ADA Compliance Program

Clark County Facilities Transition Plan Clark County Juvenile Justice Center

Date of Survey: March 27, 2006
 Conducted by: Clark County Citizen ADA Advisory Board
 Wayne Yarnall, Connie Brittain (Absent), Jesse Magana, Bud Van Cleve, Tim McVicker

Fig. 604.5.1
 Side Wall Grab Bar for Water Closet

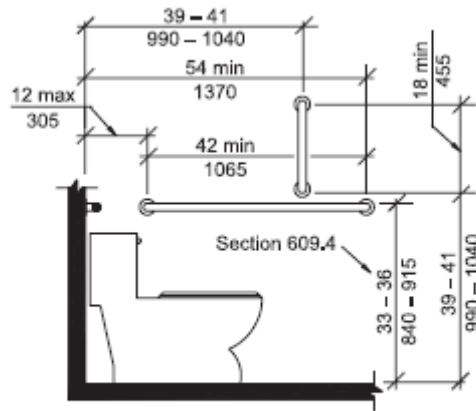
Item # 10
 Issue: Accessible Restroom – Flush Handle Location
 Issue: Vertical Grab Bar
 Location: First Floor
 Code: ANSI 604.10.6 - Flush Controls - Flush controls shall be hand operated or automatic. Hand operated flush controls shall comply with Sections 309.2 and 309.4 and shall be installed 36 inches maximum above the floor. Flush controls shall be located on the open side of the water closet.

ANSI 604.5.1 – Vertical Grab Bar

Fig. 604.5.1
Side Wall Grab Bar for Water Closet

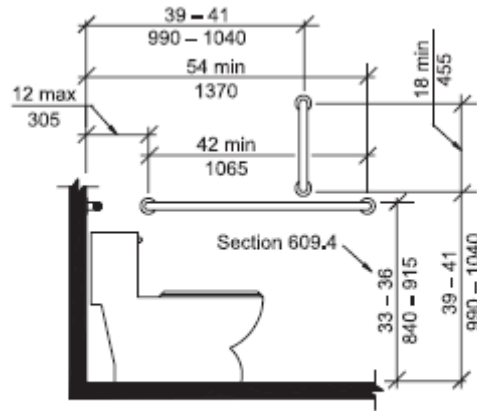
Item # 14
Issue: Flush Handle
Issue: Vertical Grab Bar
Location: North Restroom in Visiting Area
Code: ANSI 604.10.6 - Flush Controls – Flush controls shall be hand operated or automatic. Hand operated flush controls shall comply with Sections 309.2 and 309.4 and shall be installed 36 inches maximum above the floor. Flush controls shall be located on the open side of the water closet.

ANSI 604.5.1 - Vertical Grab Bars

Notes: This restroom is immediately north and adjacent to the restroom above. This restroom is accessible except for the item listed. This restroom should have signage as an accessible restroom.
